LOUISIANA
POWER & LIGHT

W3P84-0709
Q-3-P43

SUBJECT: Waterford SES Unit 3
Docket No. 50-382
Request for Relief from Certain Technical Requirements of
Appendix R to 10CFR50

ENCLOSURE 1
EXCEPTIONS FROM THE
TECHNICAL REQUIREMENTS OF 10CFR50, APPENDIX R
FOR THE REACTOR AUXILIARY BUILDING

FIGURE III.E-1

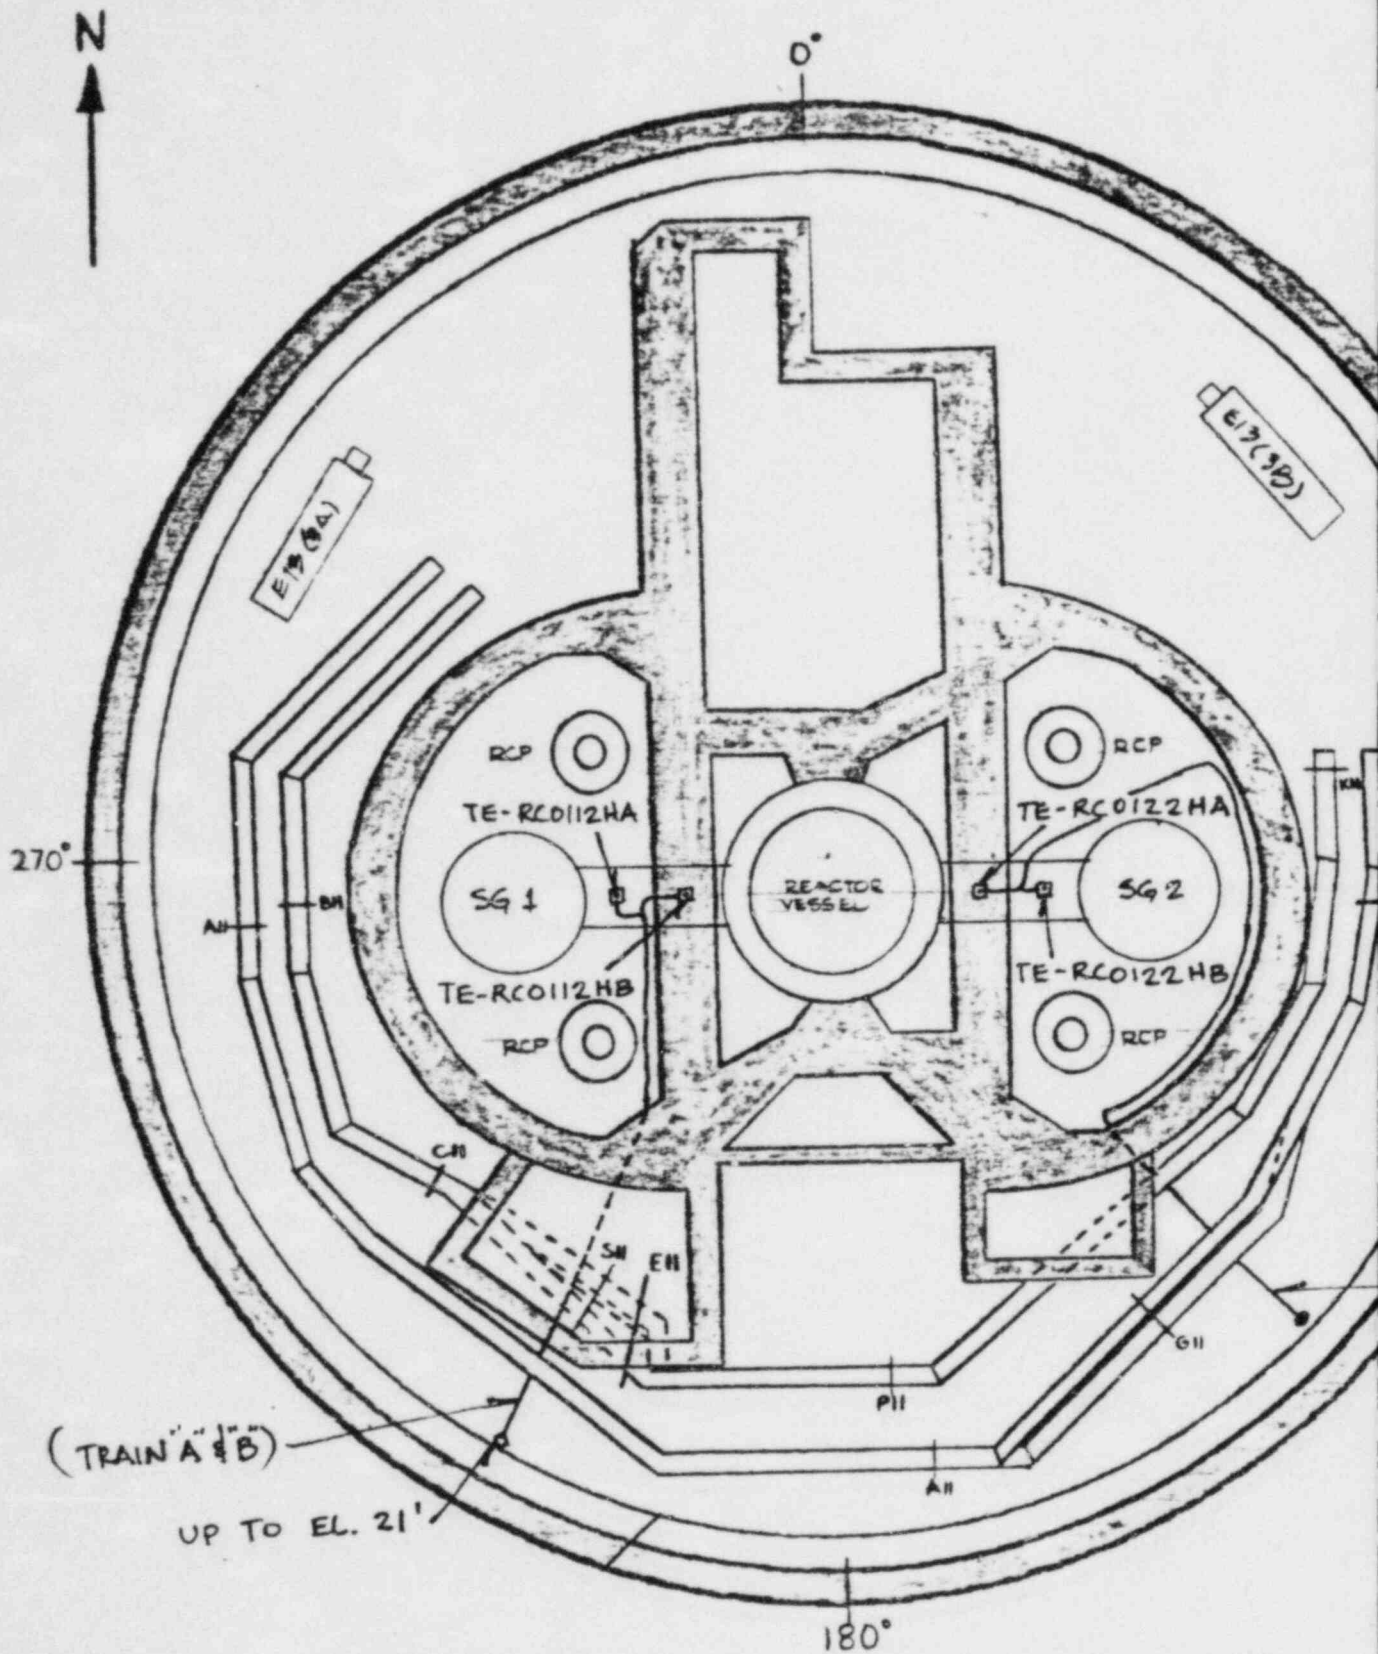
The cables are routed in exposed conduit from their respective instrument boxes, located on the hot legs at about Elevation +16.0, to the point where they are embedded in the secondary shield wall. From Figure III.E-1, it is obvious that the conduits for each loop's instruments are separated by two sides of the primary shield walls and a minimum horizontal distance of about 35 feet. The only intervening combustibles are cables and cable trays above the reactor vessel (See Figure III.E-3). The hot gases and products of combustion from a fire affecting one loop's instruments would be dissipated into the large overhead RCB volume and would not affect the other loop's instruments.

FIGURE III.E-2

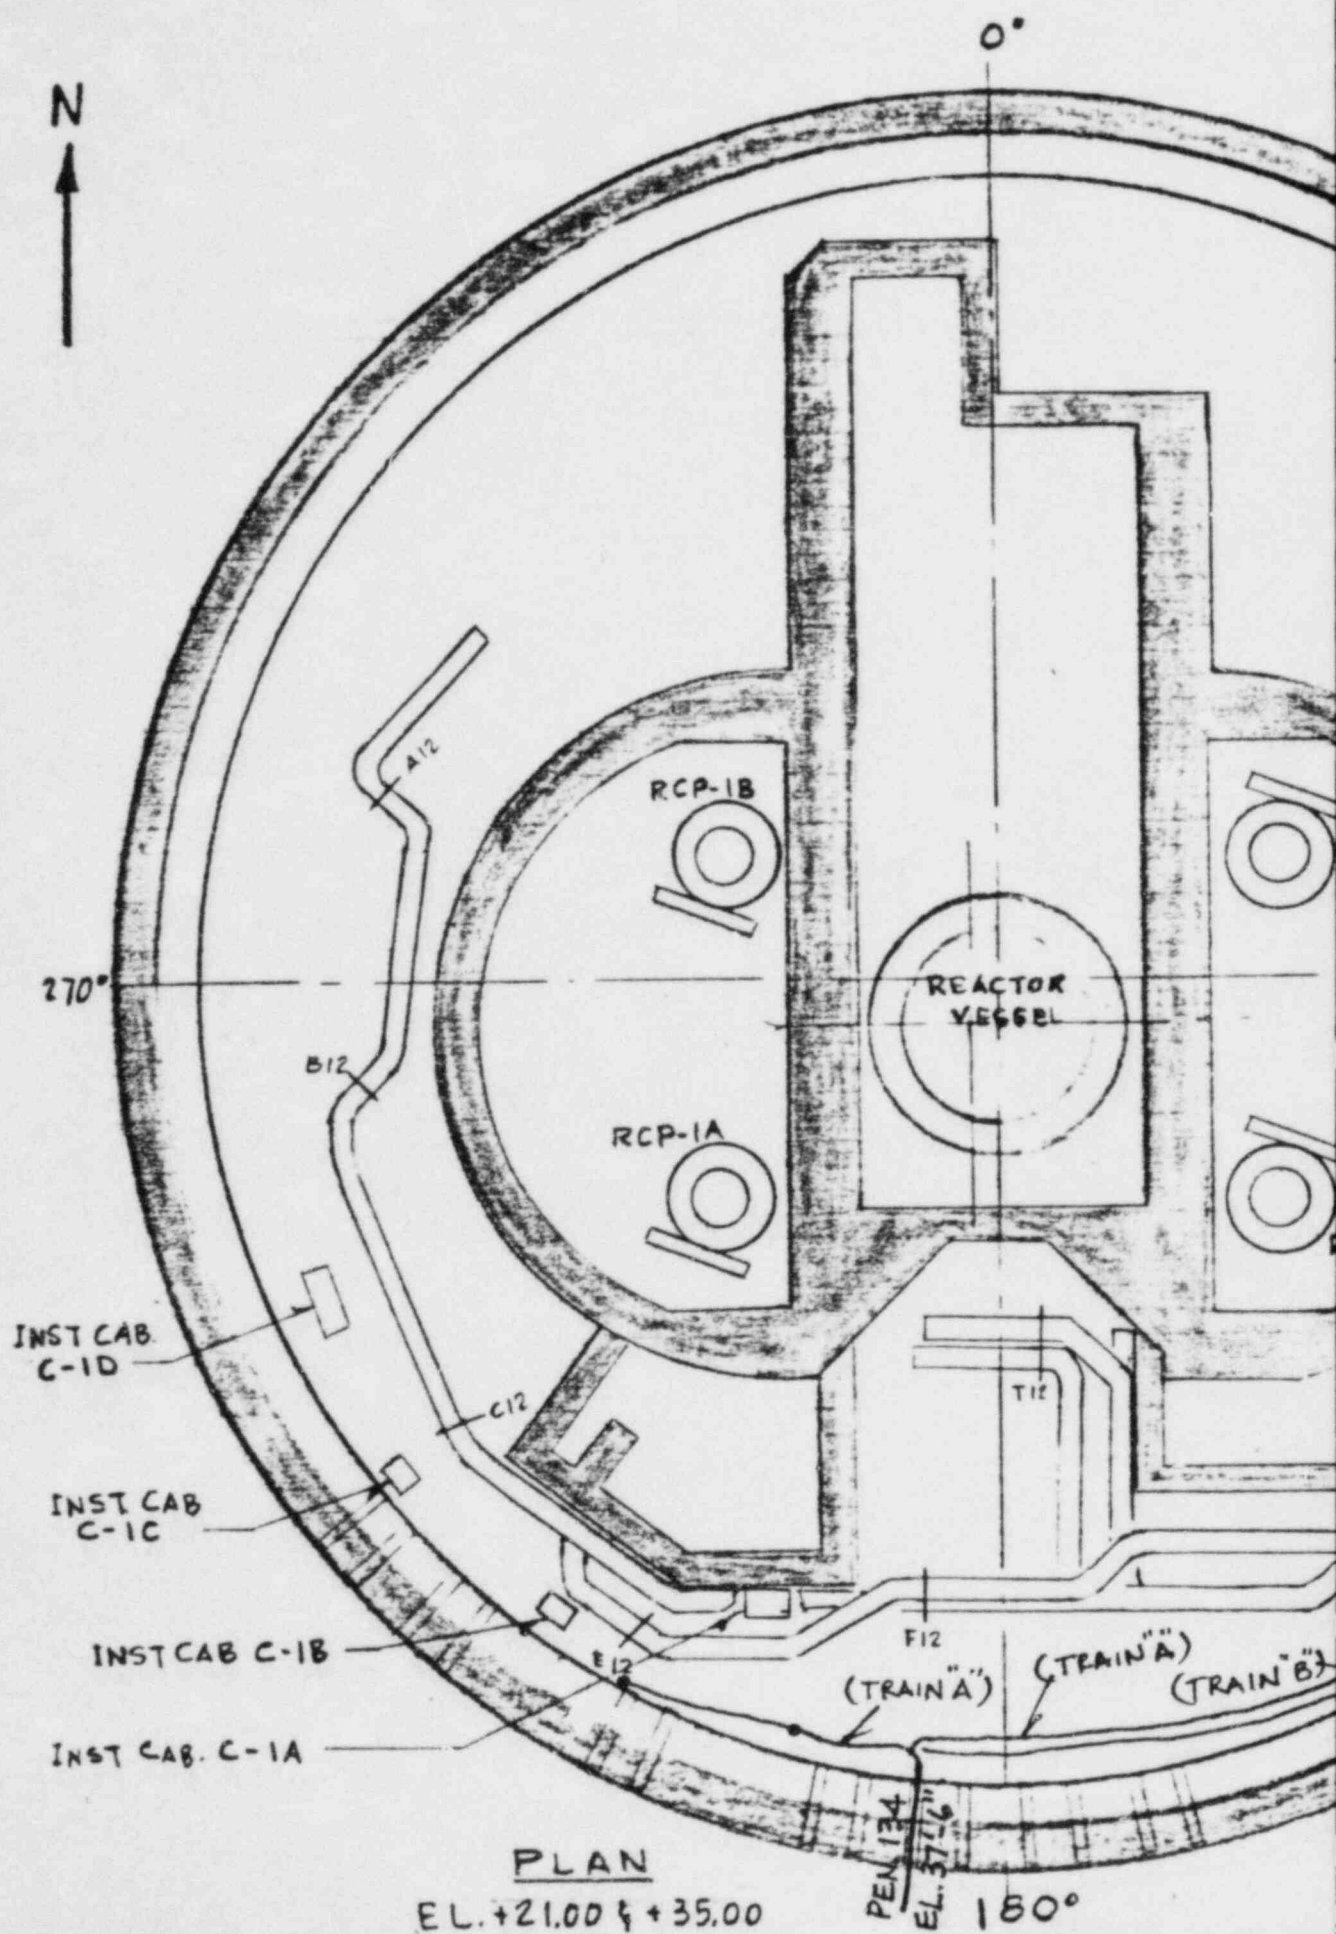
As can be seen from Figure III.E-2, there are two locations where three of the four conduits are vulnerable to the same fire, i.e. in the vicinity of the electrical penetrations. If, therefore, it is assumed that a fire occurs adjacent to Penetration 134, then RCS Loop 1 would lose both instruments, RCS Loop 2 would lose its train B instrument (TE-RCO122HB). The fourth conduit would, however, be 55 feet horizontally away from the area of fire. The intervening combustibles between the three cables assumed destroyed and the fourth would be low, consisting of two stacks of lightly loaded cable trays as indicated.

FIRE PROTECTION
REACTOR BUILDING
PLAN EL -4.00'
FIGURE III. H-1

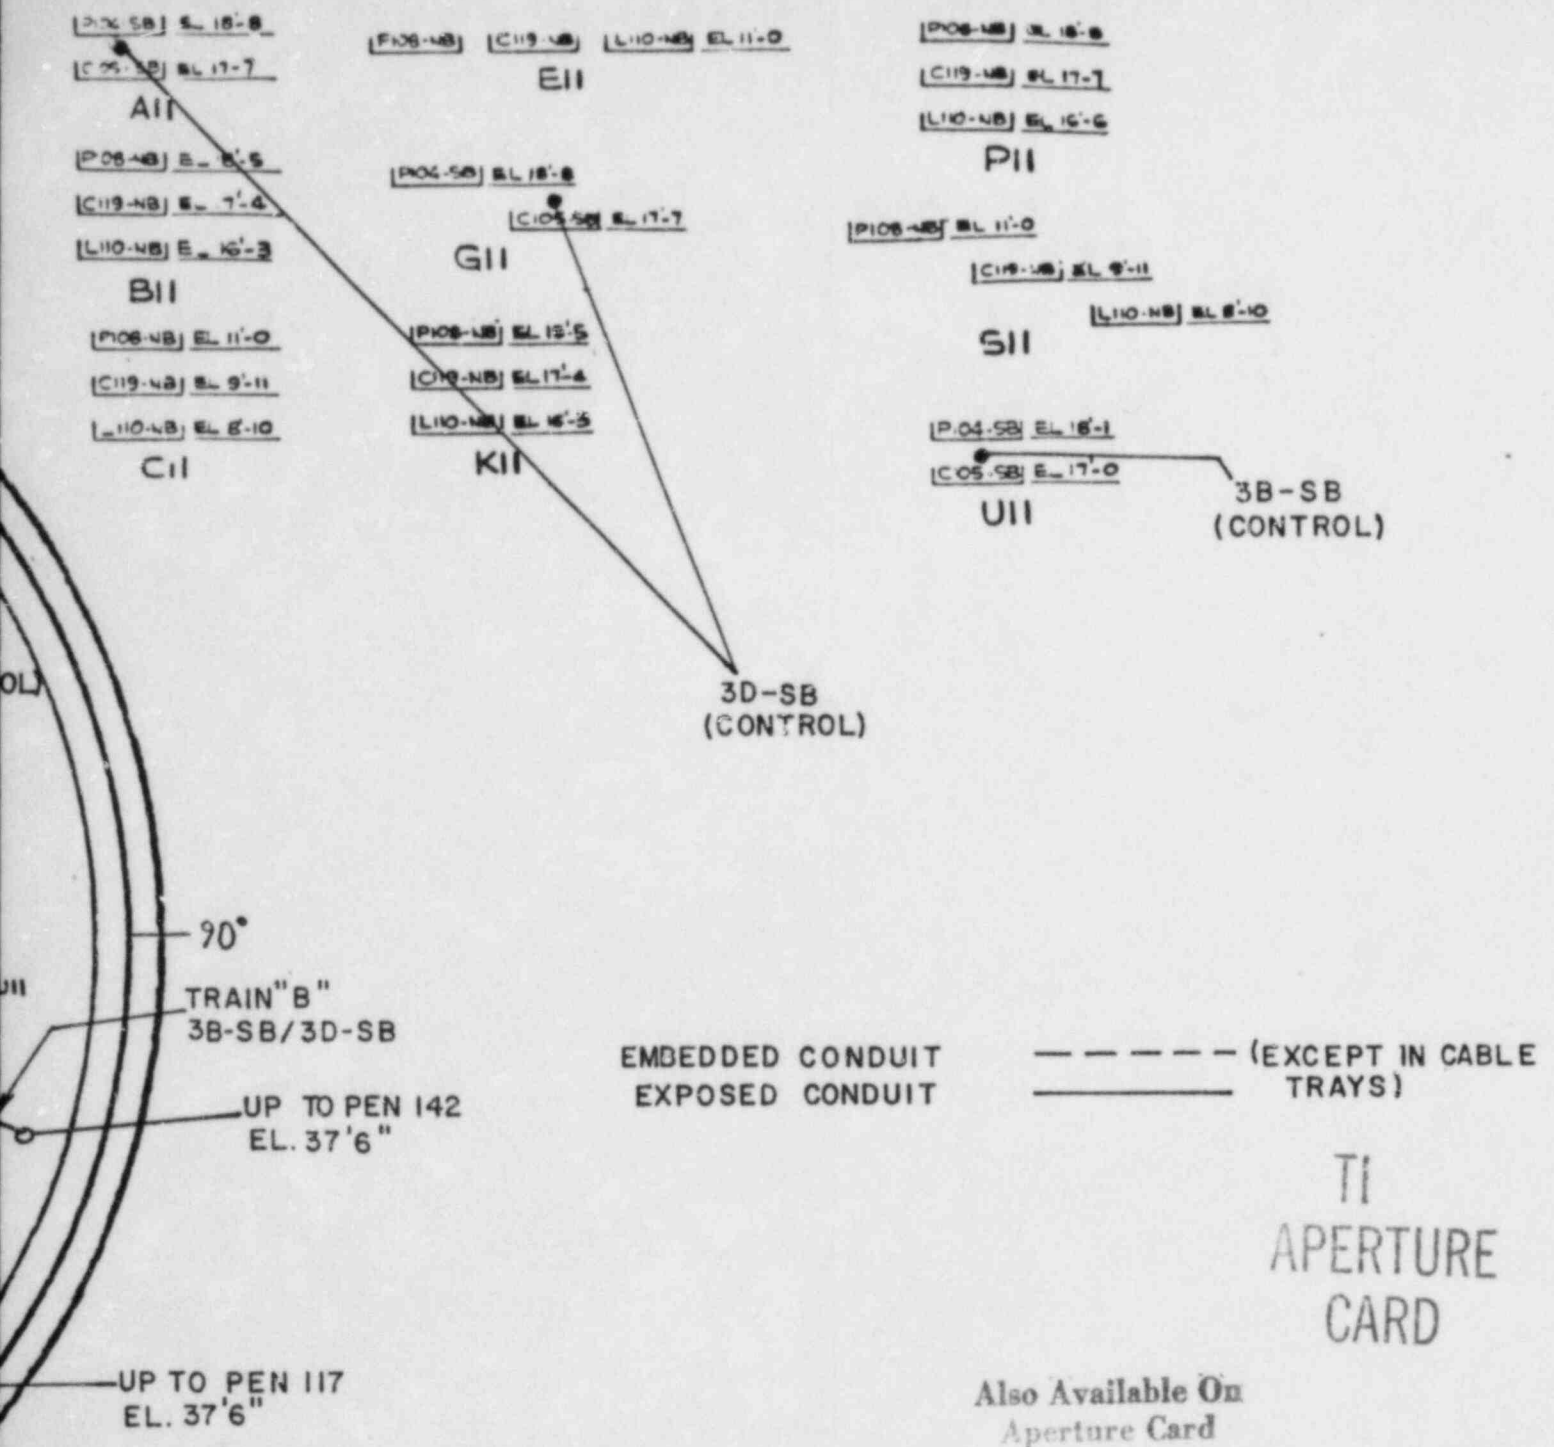
As shown in Figure III.H-1 and 2, the control cables from the two opposite sets of fan coolers run in conduit and tray outside the secondary shield wall to their respective penetrations. Control cables from units 3B-SB and 3D-SB terminate inside containment at Penetration 142; cables from units 3A-SA and 3C-SA terminate at Penetration 141. At each electrical penetration area, the control cables from 3 of 4 fan coolers could conceivably be damaged by fire.
